R44 SERVICE LETTER SL-95

R66 SERVICE LETTER SL-54

SUBJECT: C258-8 Pitch Link Assembly

C258-8 PITCH LINK ASSEMBLY

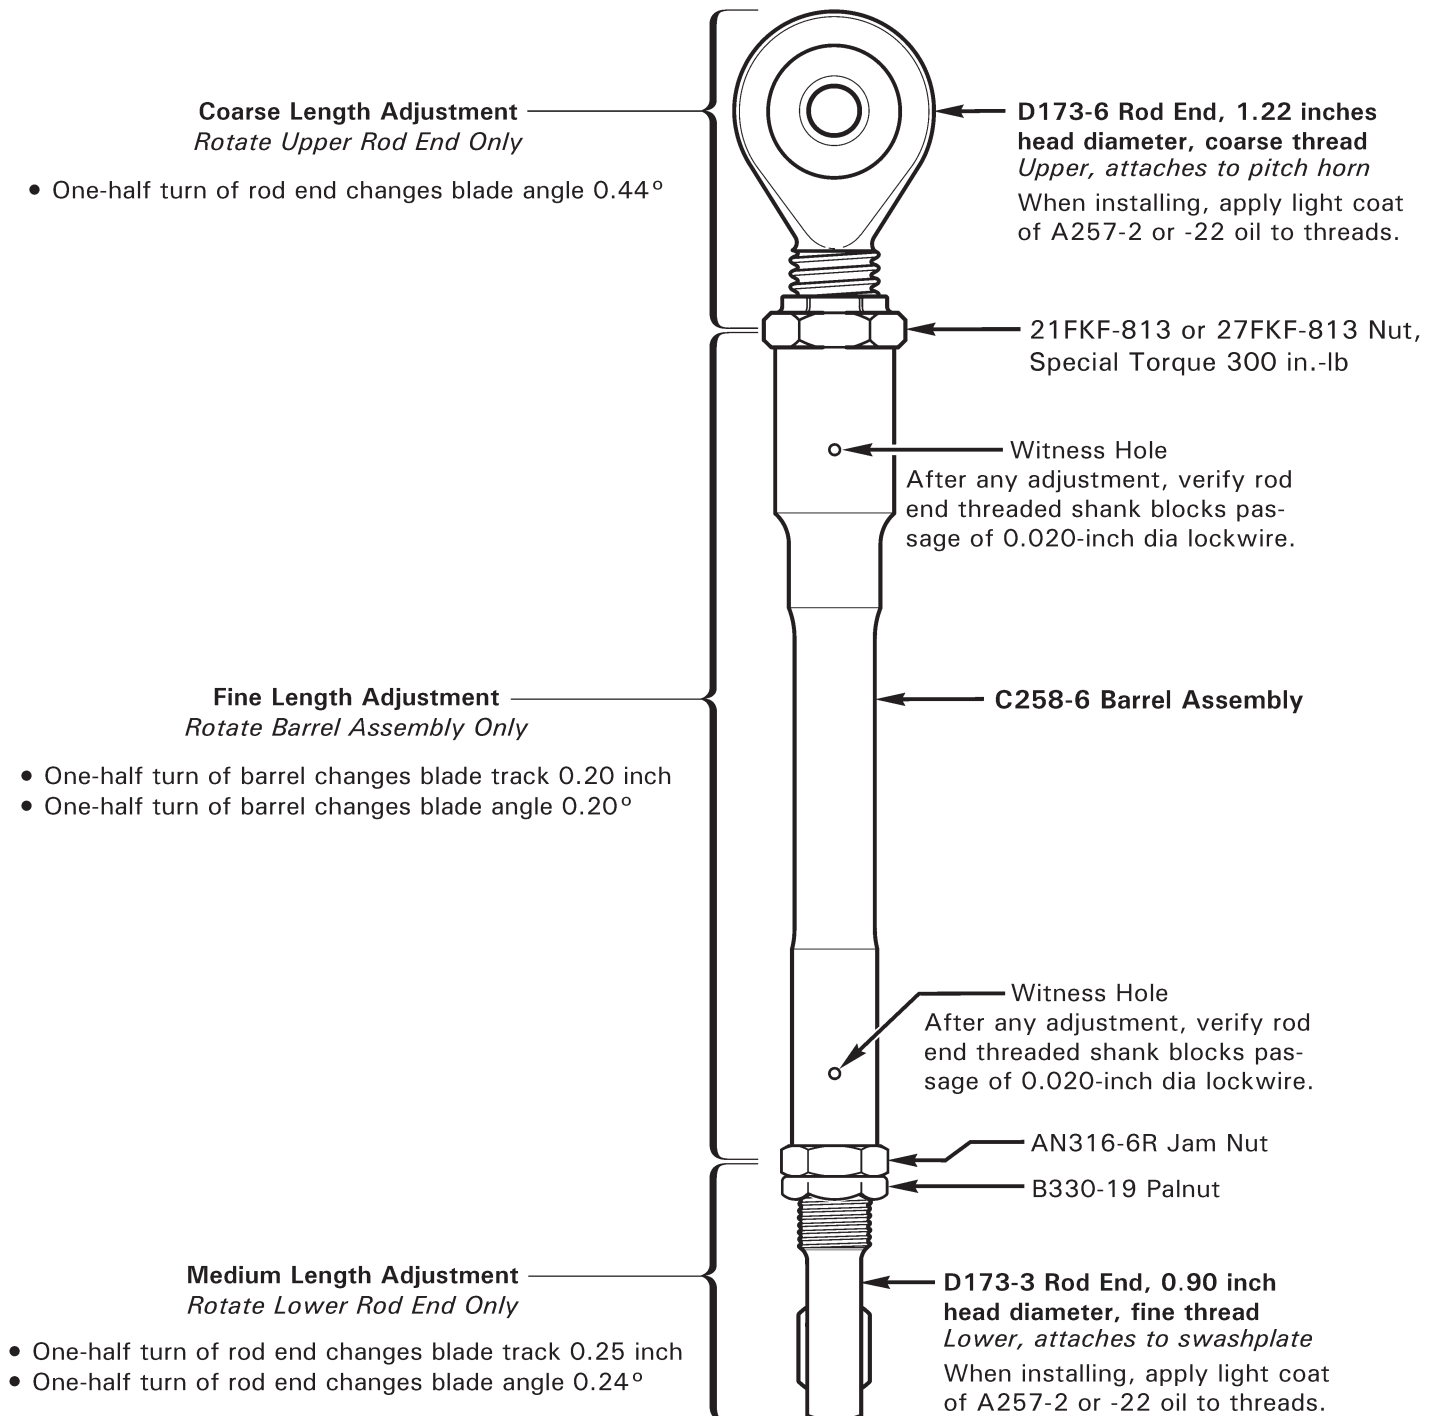
BACKGROUND: Part number C258-8 pitch link assembly for the main rotor is now being supplied on new R44-series and R66 helicopters. The C258-8 pitch link assembly features a larger, more durable upper rod end. This service letter provides instructions for installation and adjustment of C258-8 pitch link assemblies.

1. C258-8 pitch link assembly replaces C258-1 & C258-5 pitch link assemblies, and must be installed in pairs. The larger rod end must attach to the MRB pitch horn using a longer NAS6605-23 bolt in conjunction with a larger, 1.03-inch diameter C141-27 safety washer under the bolt head. Weight change is negligible.

2. When replacing pitch link assembly or pitch link parts, measure & record original link's rod end center-to-center dimension prior to disassembly; maintain recorded dimension within plus/minus 0.005 inch after installation.

3. After pitch link installation or adjustment, verify both rod end threaded shanks block passage of 0.020 inch diameter lockwire at witness holes in barrel assembly.

4. Blade tracking fine adjustment is accomplished by rotating barrel assembly while rod ends remain connected to pitch horn and swashplate.
5. Apply torque stripes for maximum preflight visibility after torquing nuts.

6. Due to a self-locking thread insert, lockwire is not required.
7. Apply light coat of A257-2 or A257-22 oil to rod end threads before installing rod end.
